DeKalb County Zoning Board of Appeals

Planning Department Staff Analysis

N1. Case No: A-26-1248005

Project Name: **Markan Quadruplex**

SITE PLANS

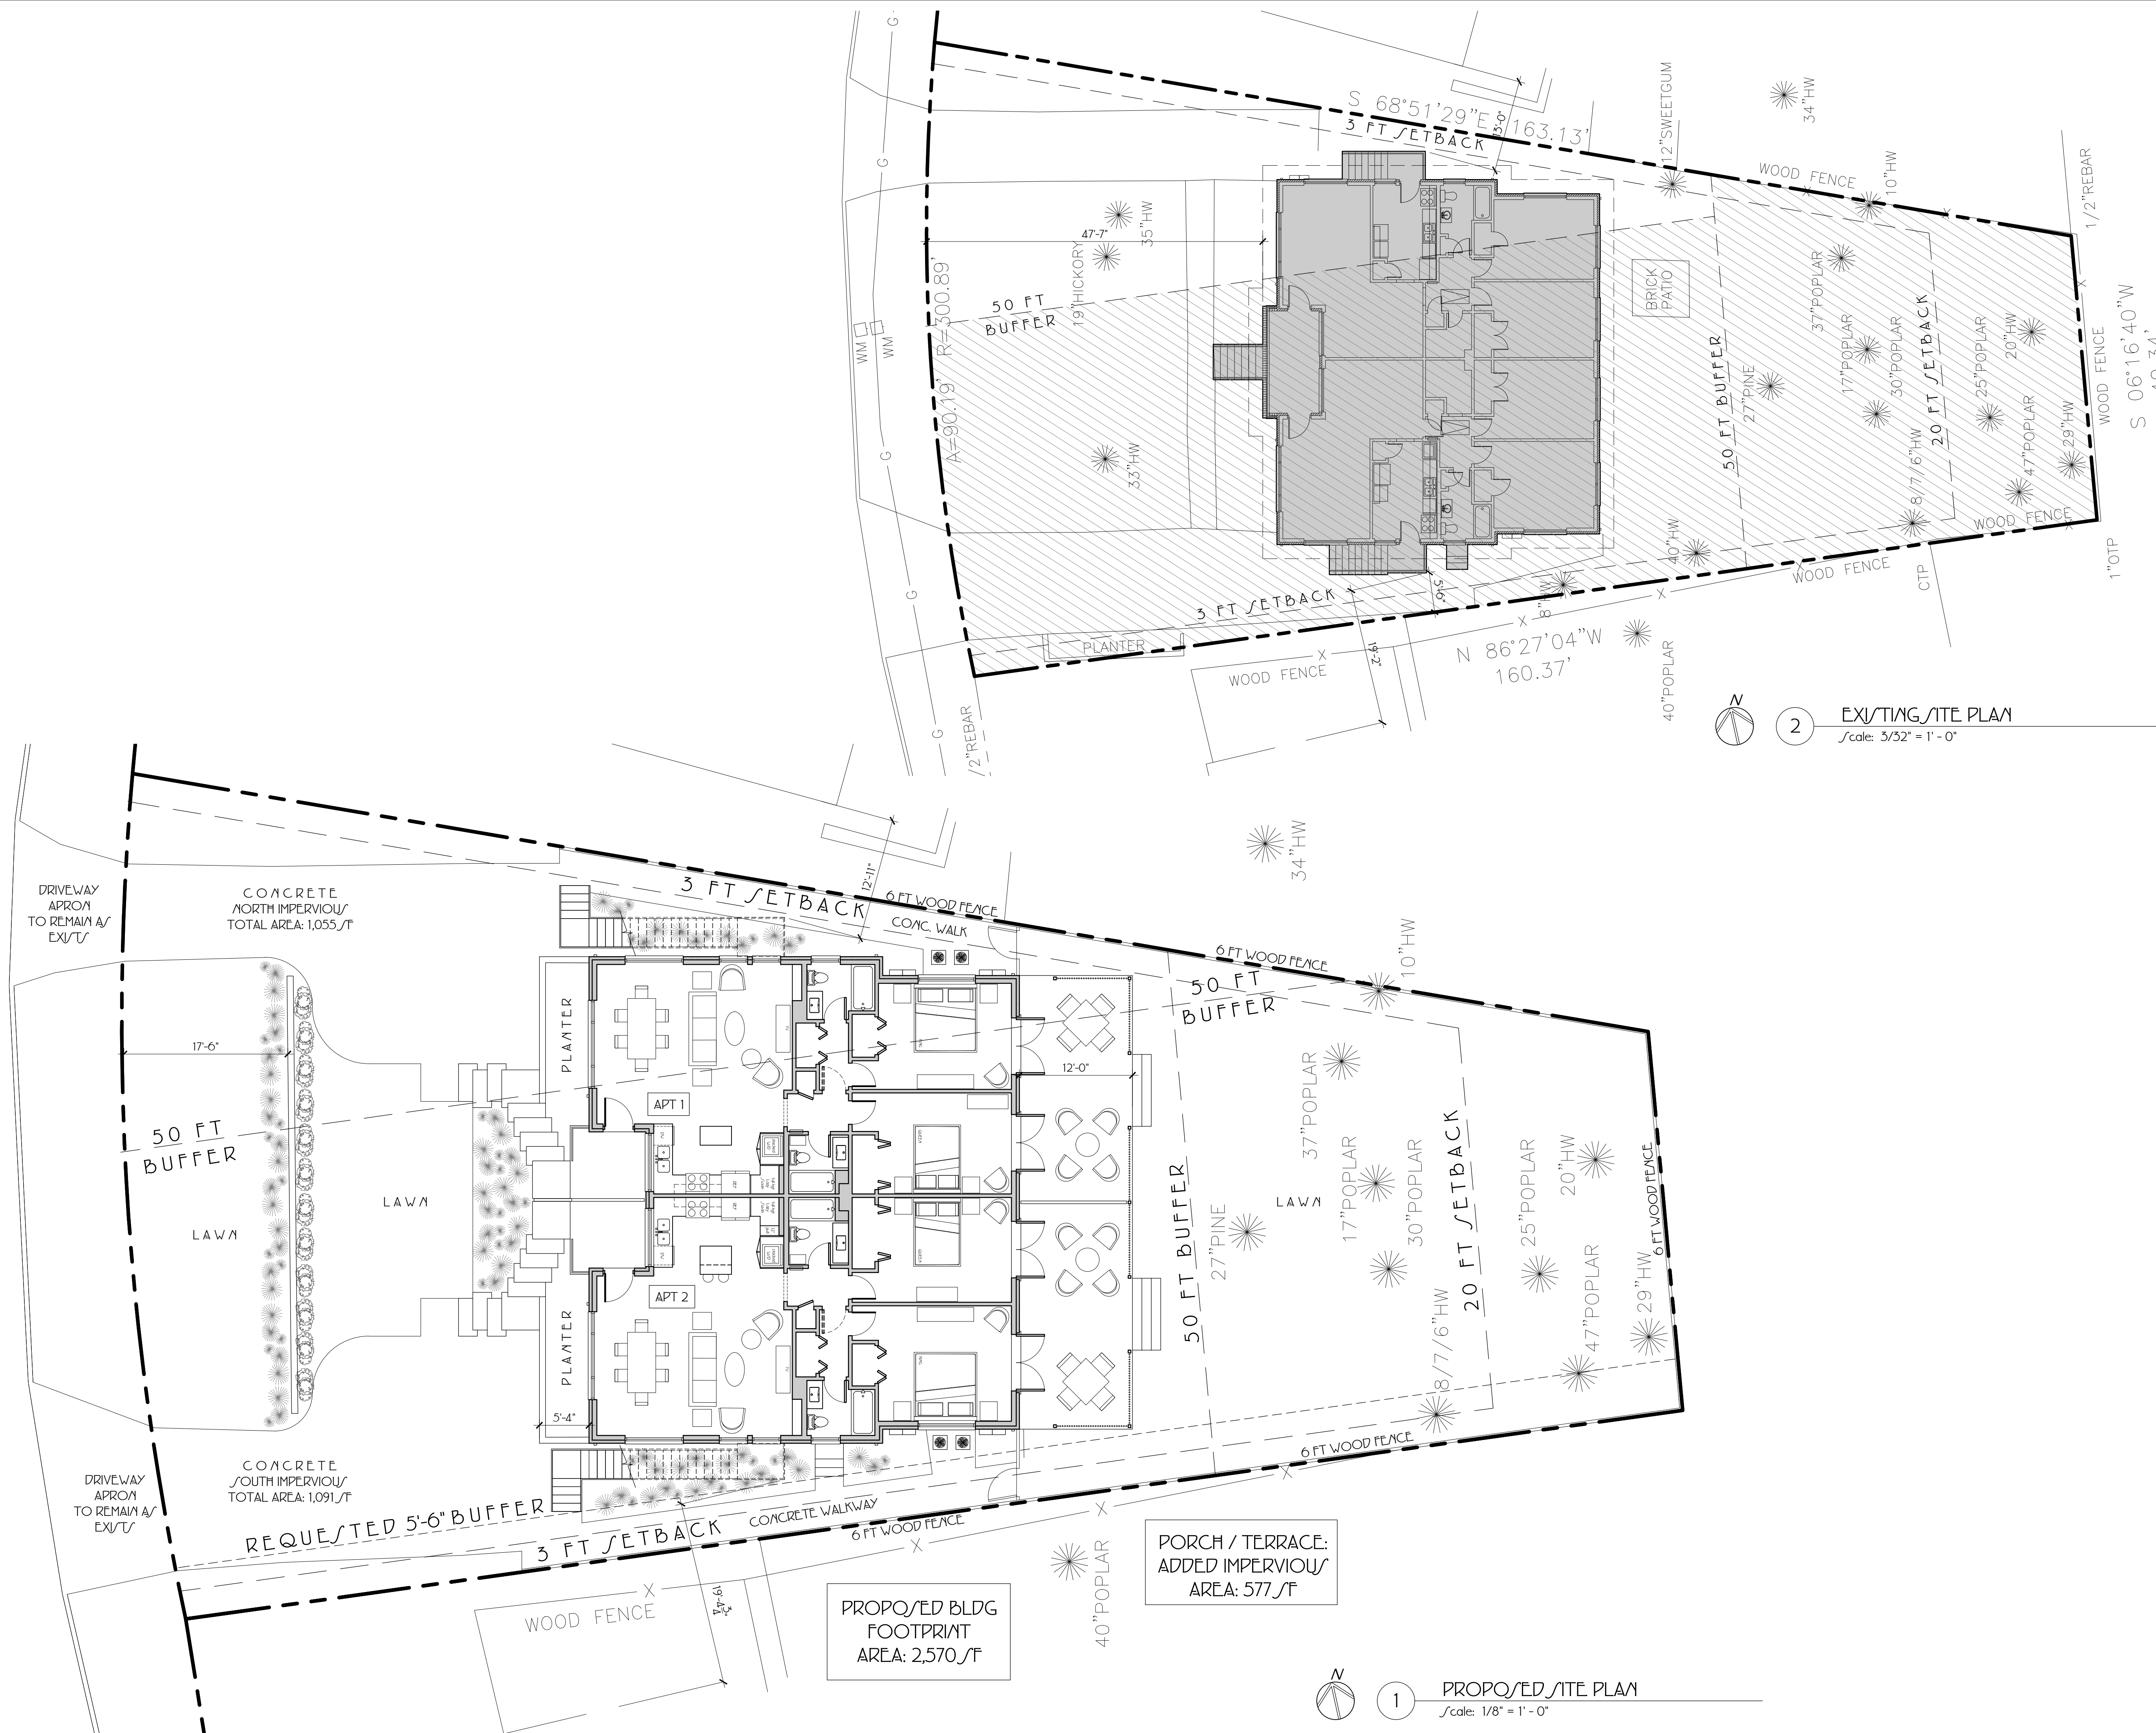
5. The final site plan shall clearly delineate all parking spaces, drive aisles, walkways, and landscaped areas. Parking spaces shall be designed and maintained so that parked vehicles do not overhang into the public right-of-way, sidewalk area, or required pedestrian access areas.

7. The final site plan shall include landscape screening or planting areas between the front-yard parking areas and Markan Drive, where feasible, to soften the visual impact of parked vehicles from the street. Required screening shall be maintained in healthy condition.

5. The final site plan shall clearly delineate all parking spaces, drive aisles, walkways, and landscaped areas. Parking spaces shall be designed and maintained so that parked vehicles do not overhang into the public right-of-way, sidewalk area, or required pedestrian access areas.

7. The final site plan shall include landscape screening or planting areas between the front-yard parking areas and Markan Drive, where feasible, to soften the visual impact of parked vehicles from the street. Required screening shall be maintained in healthy condition.
